CITY OF NOVI CITY COUNCIL
JUNE 26, 2023

SUBJECT: Approval of the request from Parc Vista subdivision for a variance from Design and Construction Standards Section 11-68(a) to allow a flow of approximately 1,900 gallons per minute instead of the 2,000 gallons per minute required for single-family residential subdivisions.

Re: Variance from Design & Construction Standards
 Parc Vista – Lower available water flow

FLOW TEST SUMMARY REPORT page 1

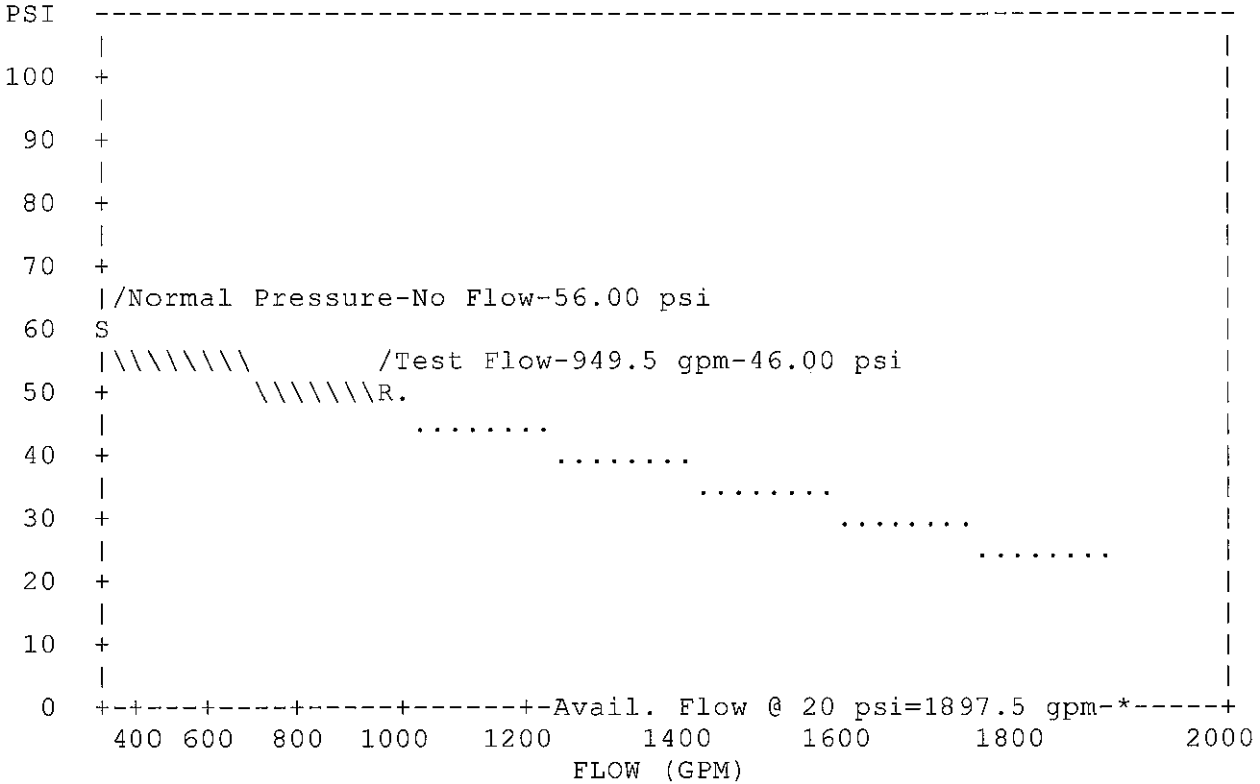
The hydrant flow test conducted indicates ~1,900 gallons per minute (GPM) will be available, which is only 5% less than the 2,000 desired flow rate.
